STATE OF MAINE
DEPARTMENT OF TRANSPORTATION
16 STATE HOUSE STATION
AUGUSTA, MAINE 04333-0016

March 21, 2014
Subject: **Augusta Phase 2**
State Project No: 020118.20
Amendment No. 1

Make the following change to the Bid Documents:

SKM-01
AMENDMENT #1

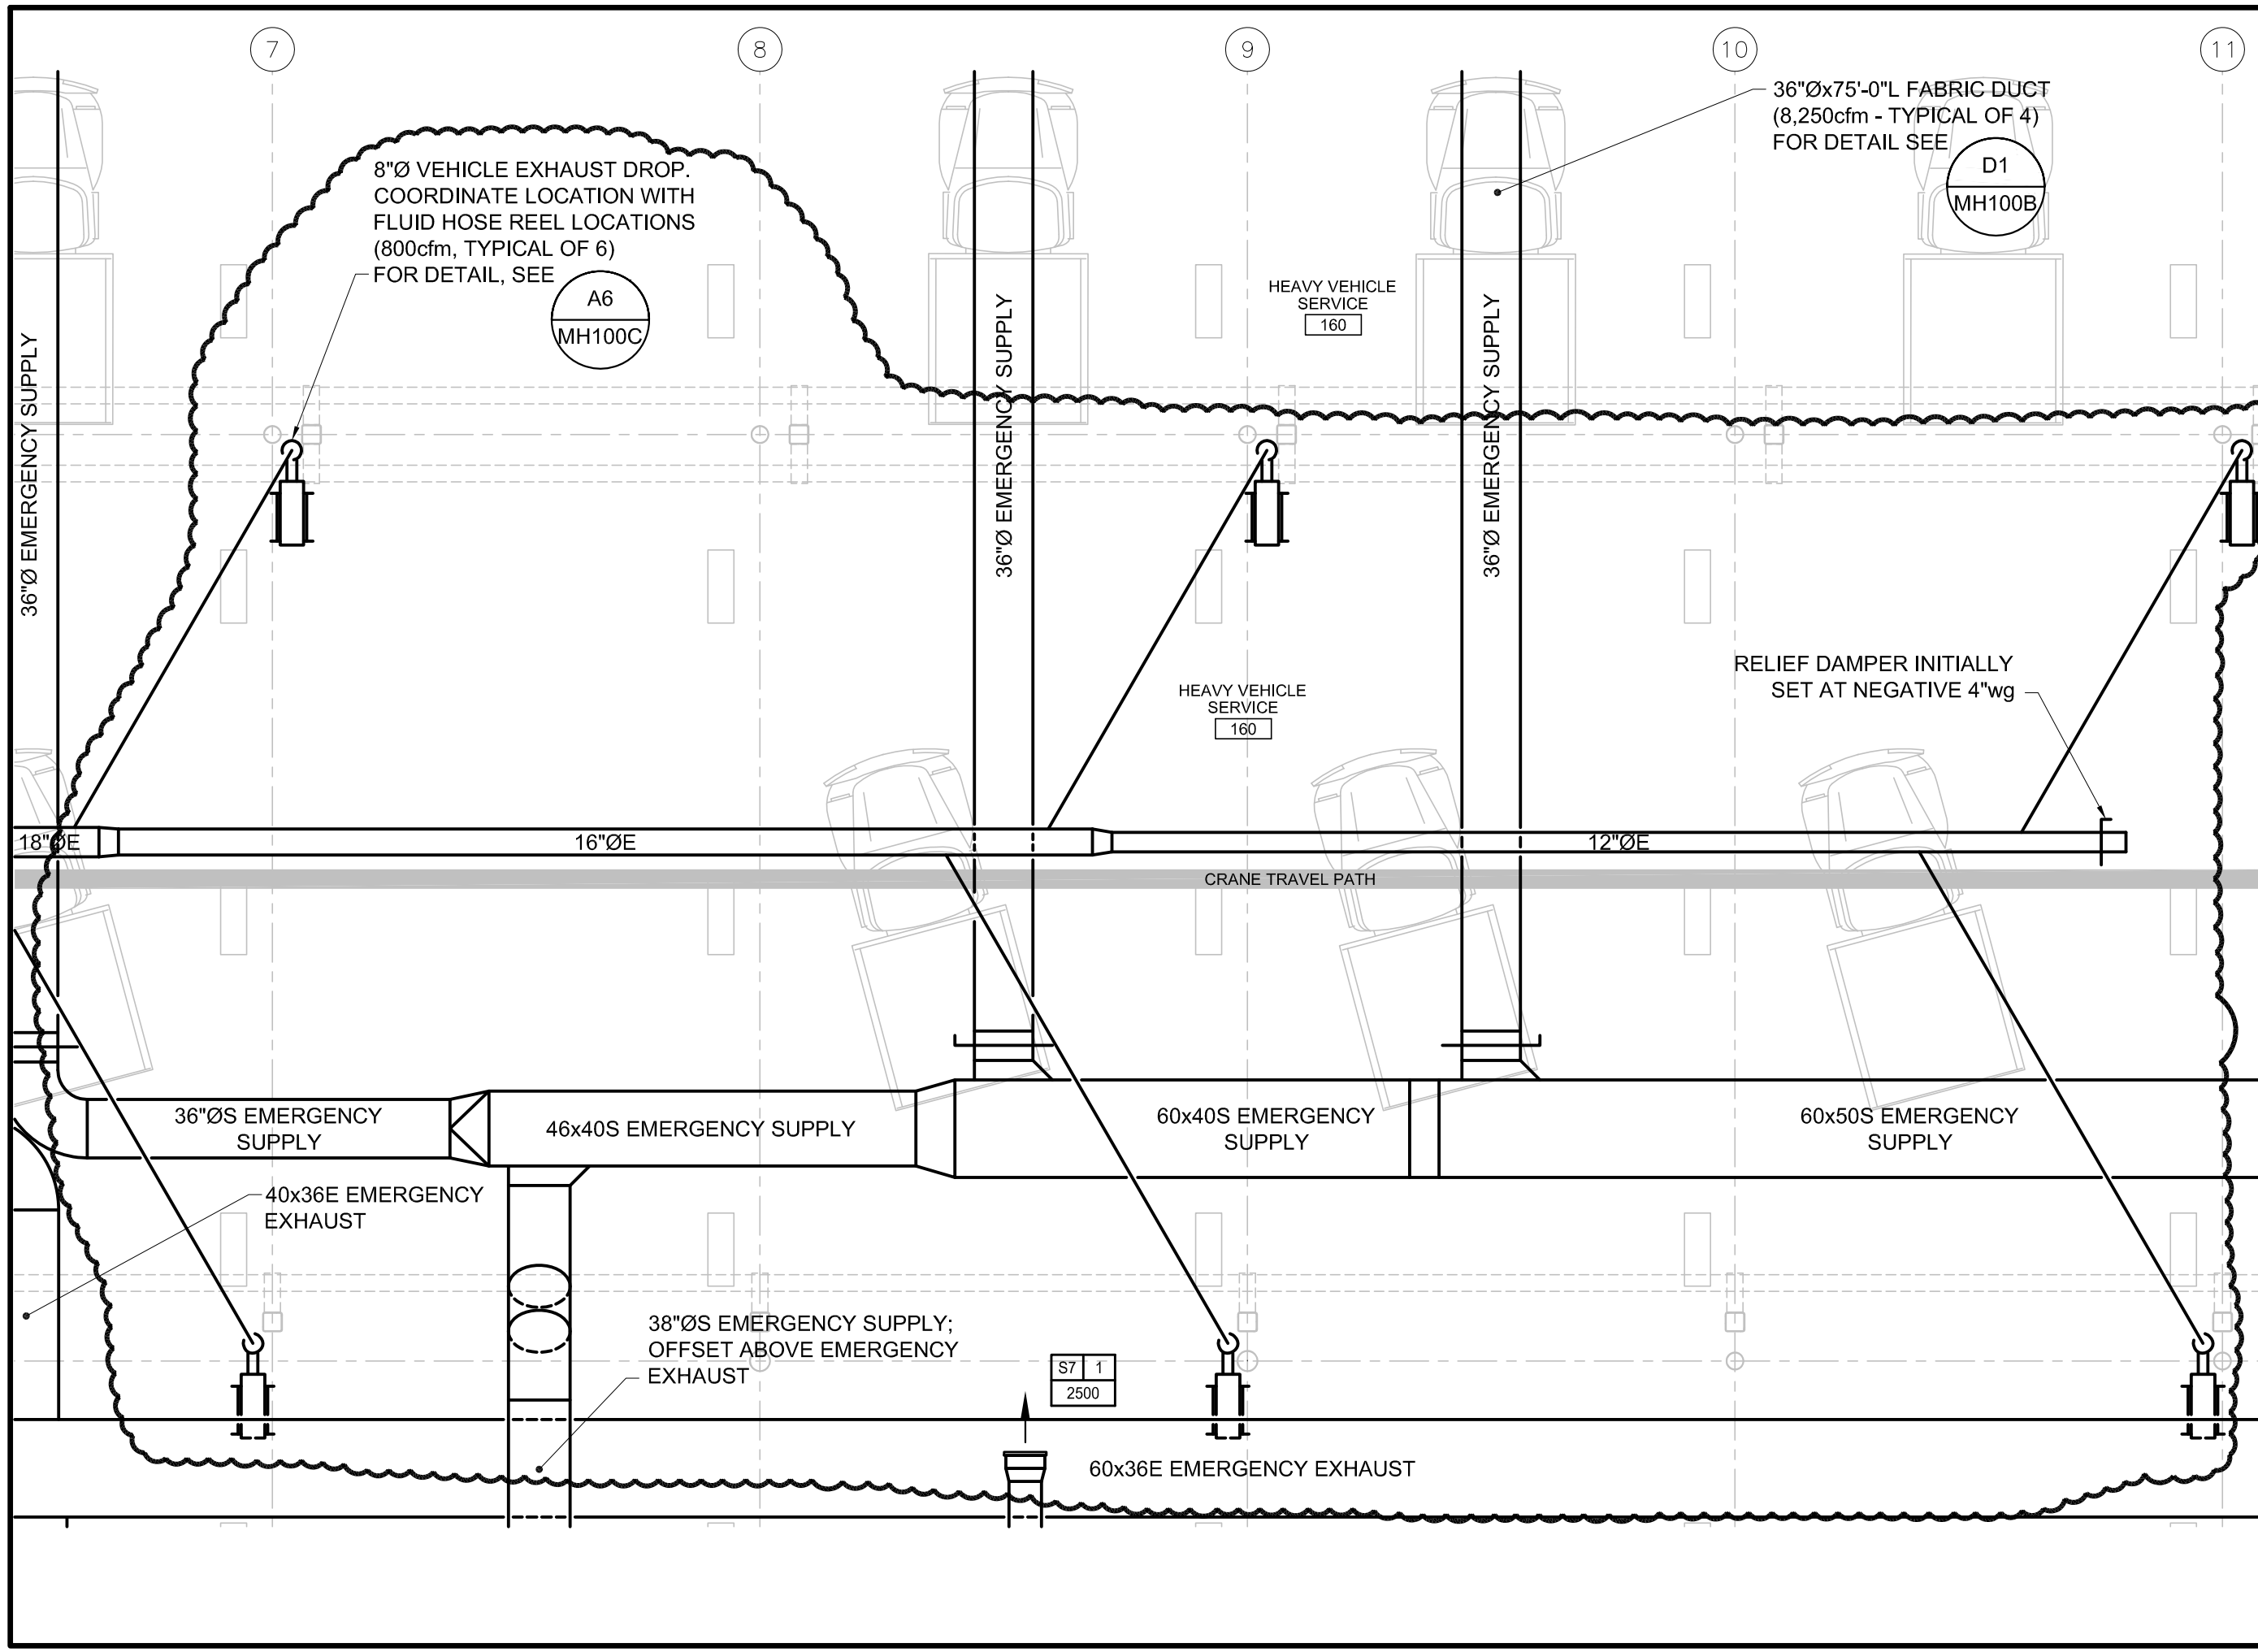
On plan Sheet MH100B Titled Mechanical Part Plan First Floor – Area B, **REVISE** drawing per SKM-01 (Revised Heavy Vehicle Exhaust Duct/Hose Reels.)

REVISED HEAVY VEHICLE EXHAUST DUCT/HOSE REELS
~ C1 - SHEET MH100B

REVISED LIGHT VEHICLE EXHAUST DUCT/HOSE REELS
~ A1 - SHEET MH100C

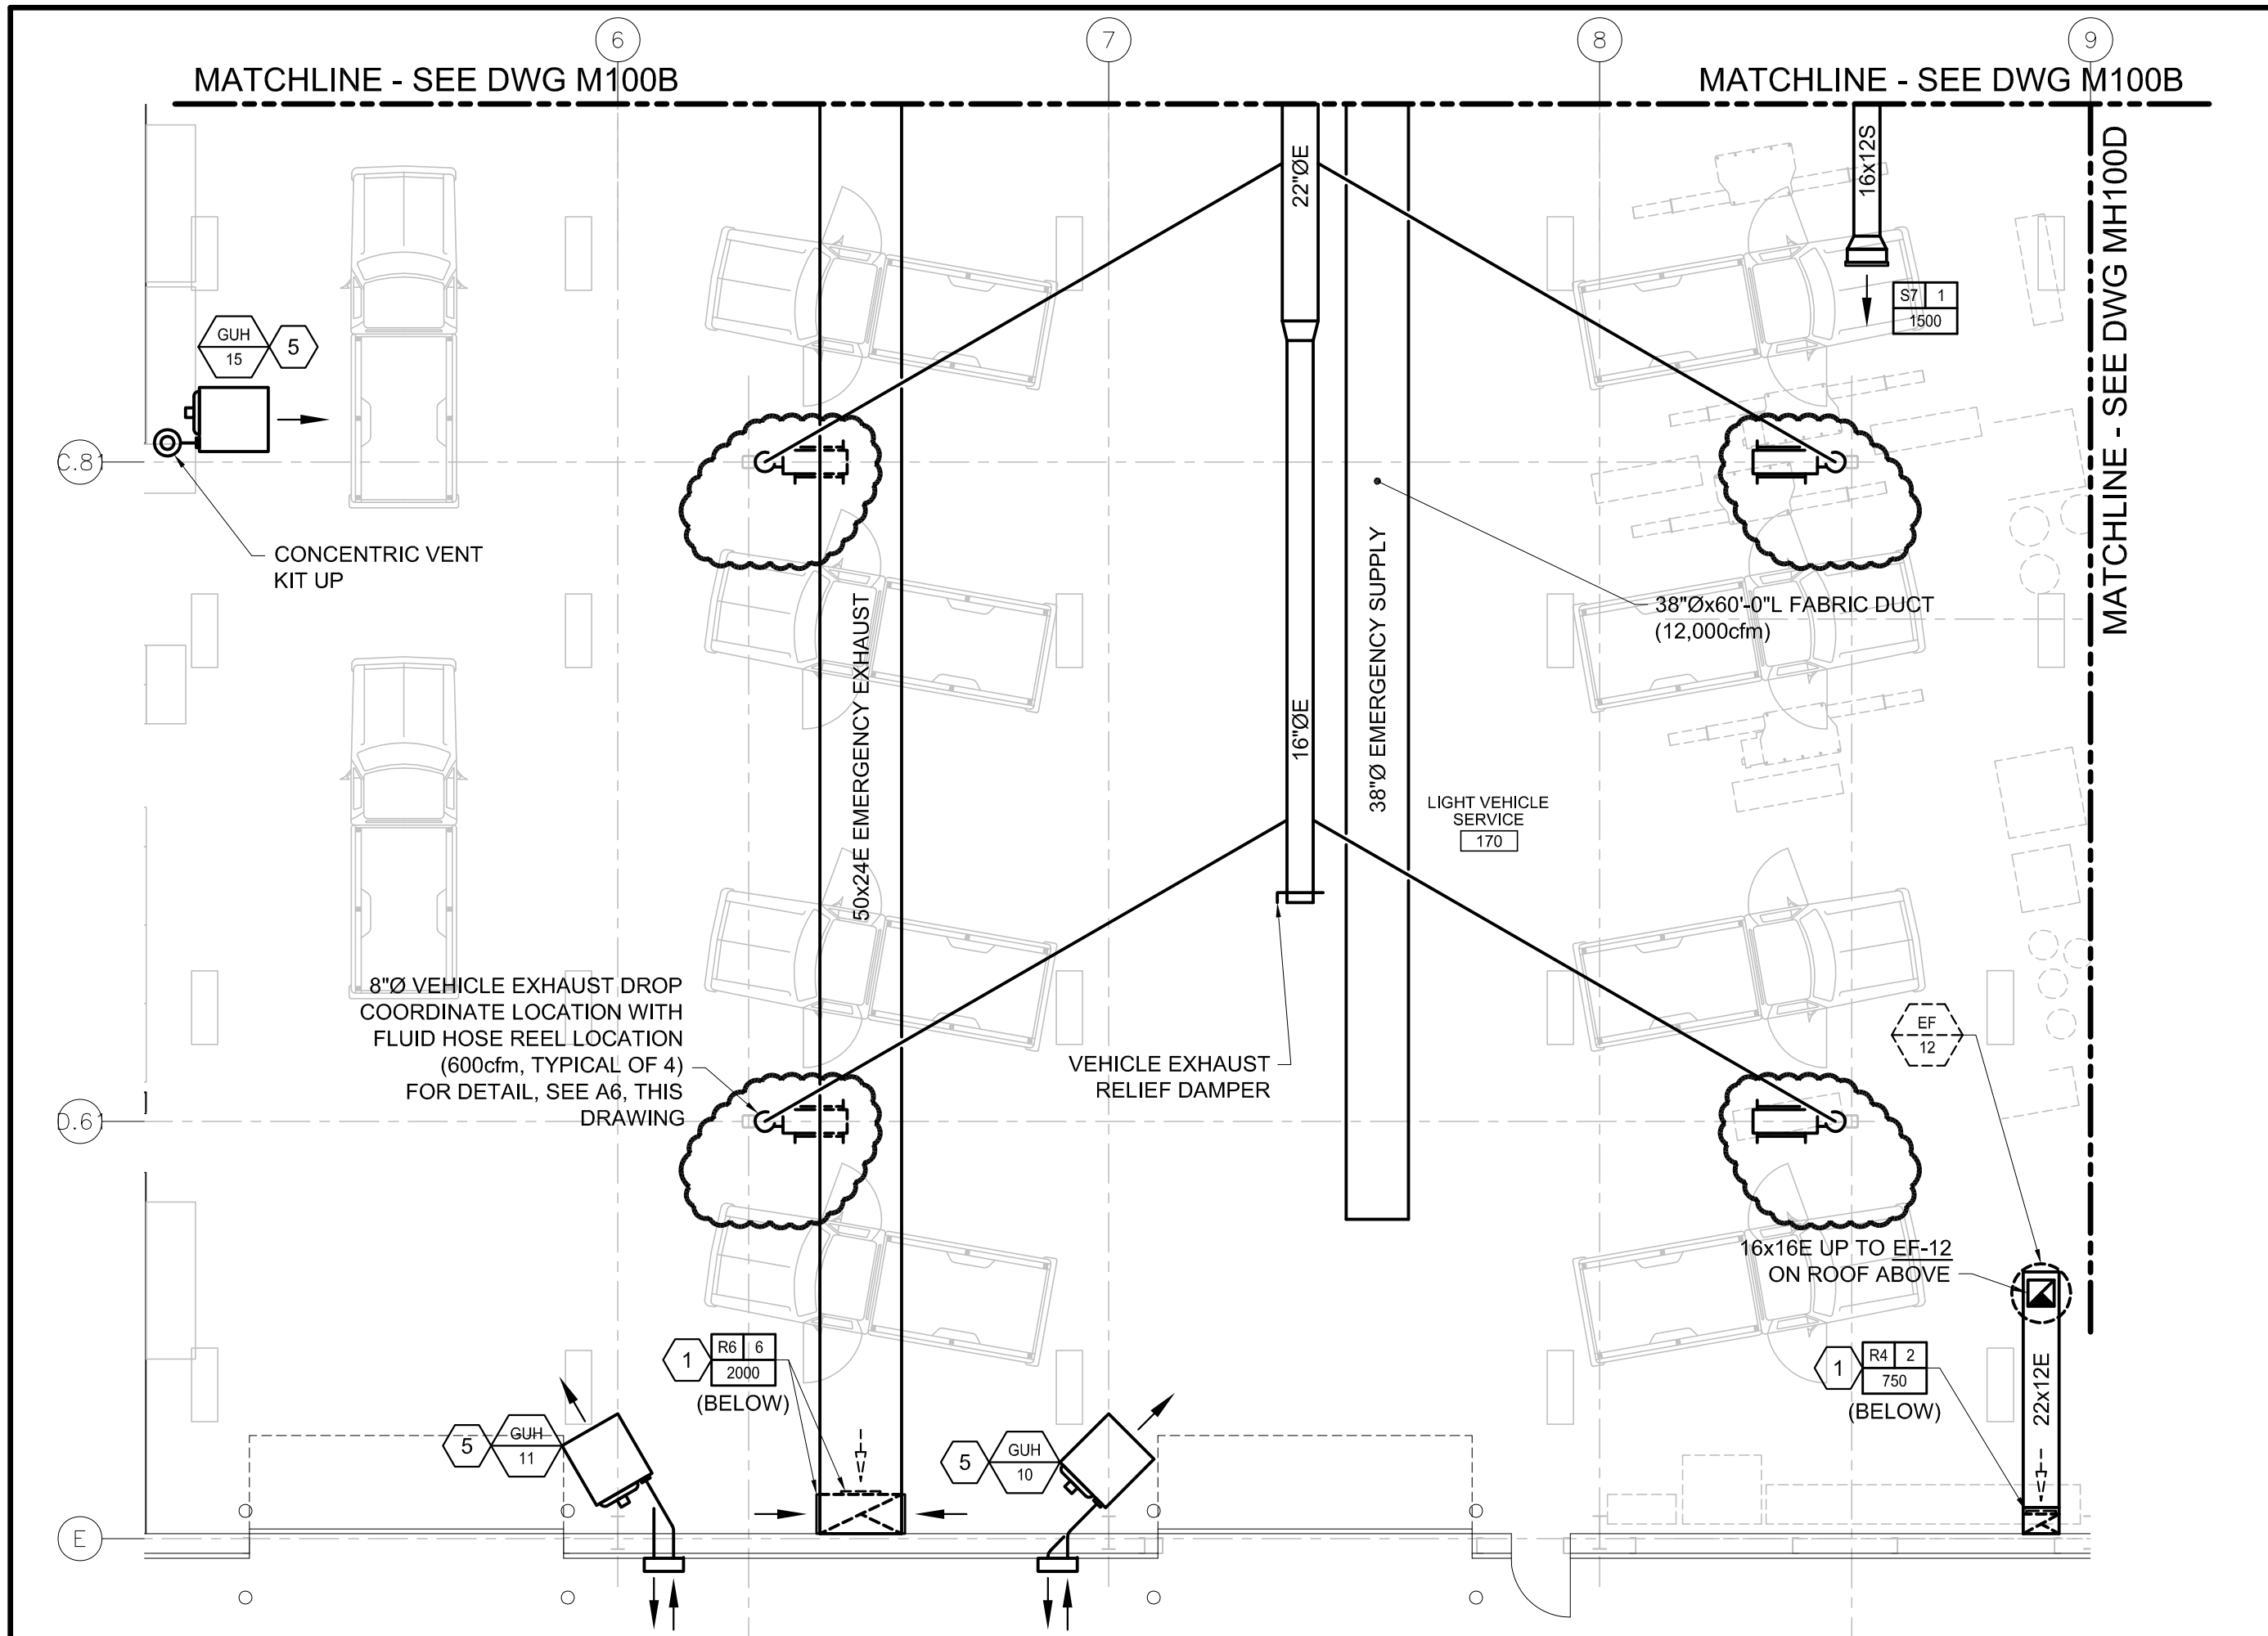
On plan Sheet MH100C Titled Mechanical Part Plan First Floor – Area C, **REVISE** drawing per SKM-02 (Revised Light Vehicle Exhaust Duct/Hose Reels.
